ATTENTION XR OWNERS

Jeep XR and 392 models feature taller/longer front and rear bump stops from factory.

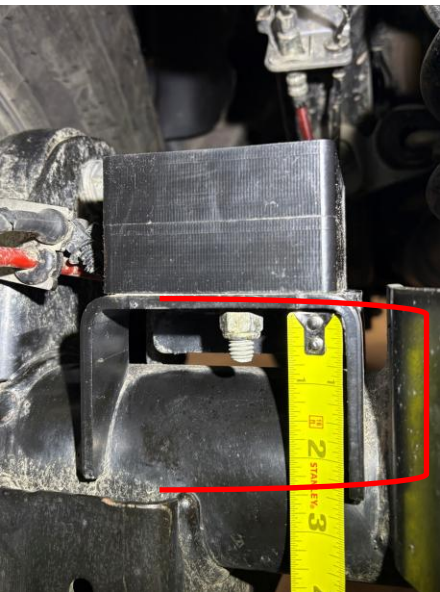
Tall Bump Stop Pad
on XR/392 JL's

Short Bump Stop Pad
on "Standard" JL's

Tall Bump Stop Tower
on XR/392 JL's

Short Bump Stop Tower
on "Standard" JL's

XR/392 models need to swap to shorter FRONT AND REAR bump stop extensions.

Short Rear Extension : COR-1409201

Short Front Extension: COR-1409101
